**Re: GE-Pittsfield/Housatonic Site Upper ½-Mile Reach Removal Action
Response to Questions/Comments on DNAPL Proposal**

March 6, 2000 USEPA Questions/Comments

March 14, 2000 USEPA Comments

Attachment 3

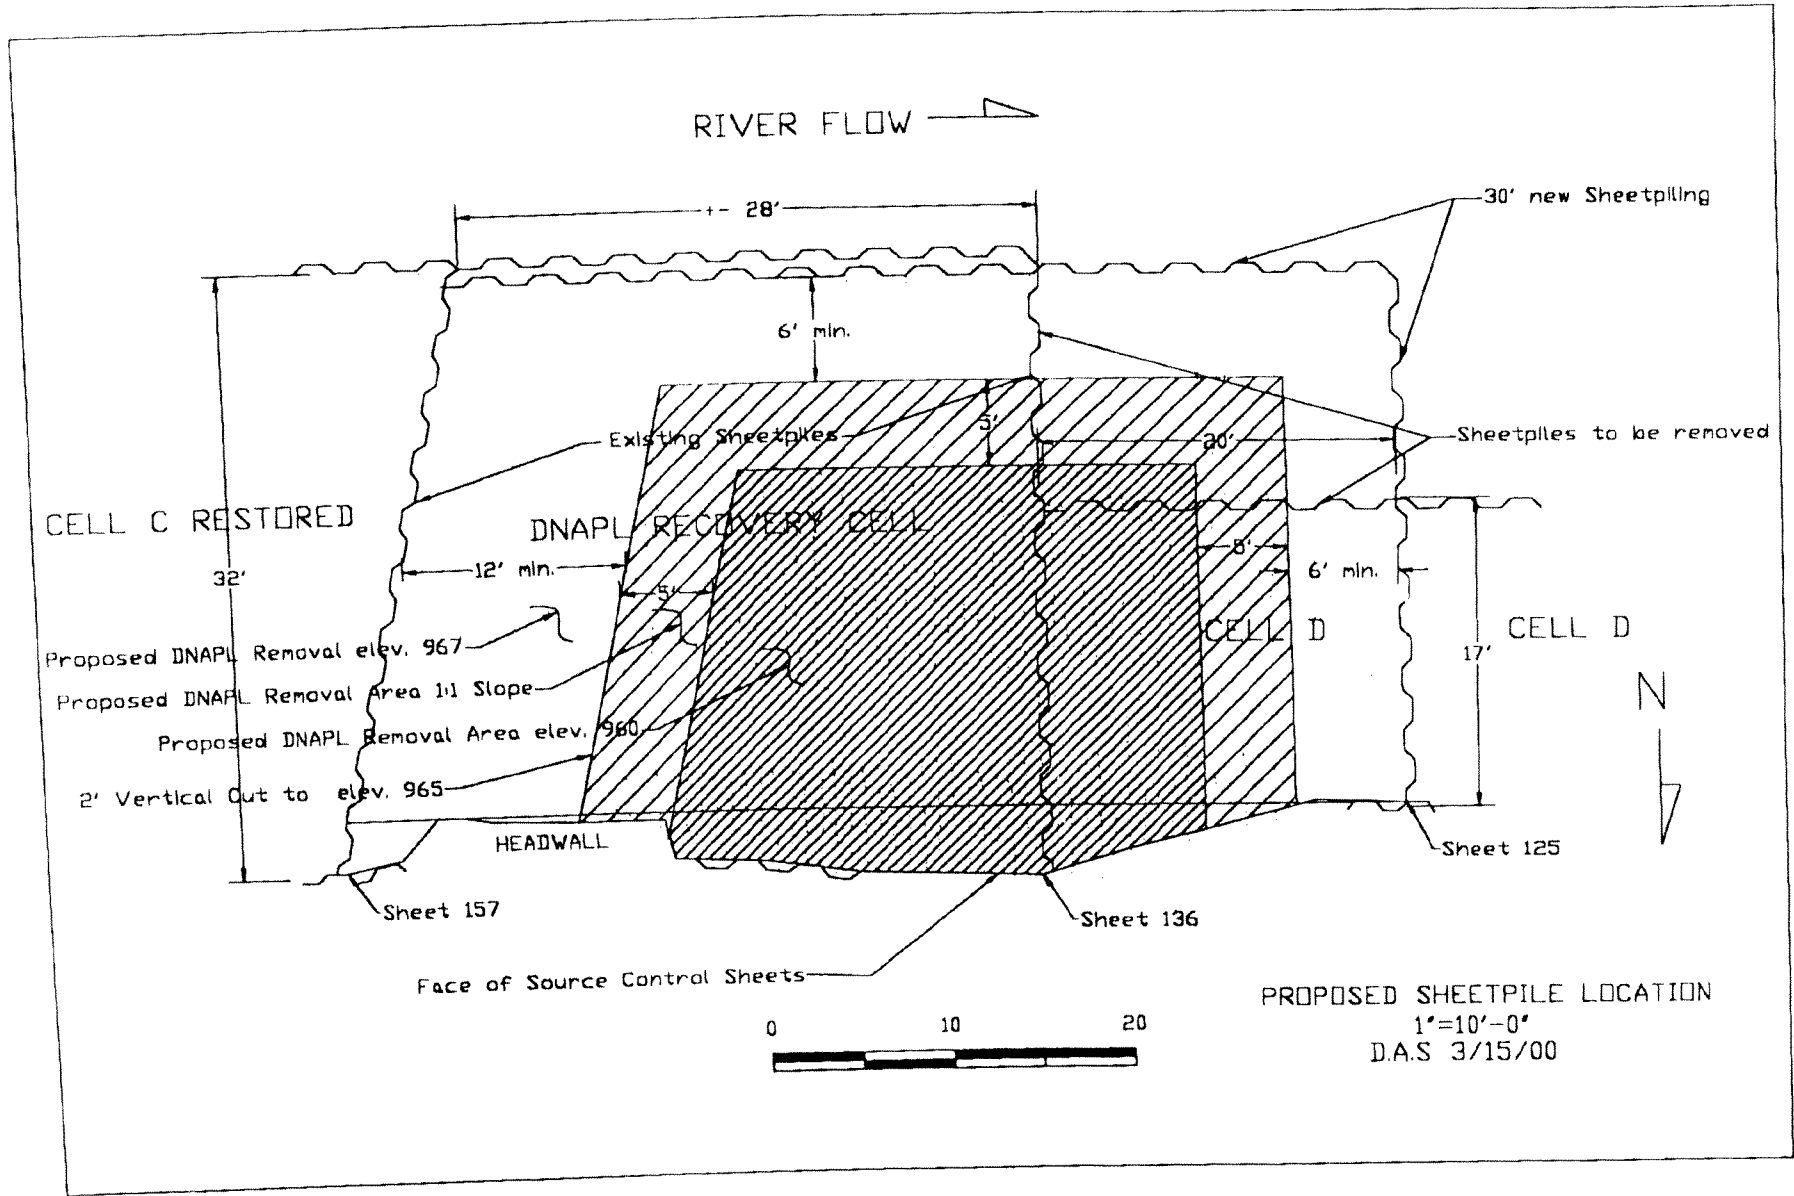
Comment 1: Minimum limits of the excavation may need to be expanded.

Comment 2: Downstream location of the proposed cut-off wall may need to be extended 15 feet.

Comment 1: Clearly delineate the vertical and lateral extent of the initial excavation.

Response: The horizontal and vertical limits of excavation will be expanded based on visual observations. As recommended by the USEPA, the maximum vertical limit of excavation will extend to elevation 960 feet (see Attachment 3).

Response: Per verbal agreement with USEPA, the downstream location of the proposed cut-off wall has been installed 20 feet from the existing Cell C and D divider wall (see Attachment 3).

Response: As described above, GE anticipates excavating a sump, and potentially a water collection trench, along the base of the source control sheetpiling to an elevation of 960. The trench would be installed along the finely crosshatched area on Attachment 3. The initial excavation limits are represented by the finely crosshatched area and its intersection with the original boundaries of Cell C. This area would be initially excavated to an elevation of 961 (which would assist in facilitating water collection efforts at the trench/sump). The eastern, western and southern borders of this area would be sloped as shown on Attachment 3. Based on visual observation in the field, the excavation area could expand towards Cell D to the maximum extent illustrated on Attachment 3. If warranted, the finely crosshatched area would be excavated to an elevation of 960 feet.
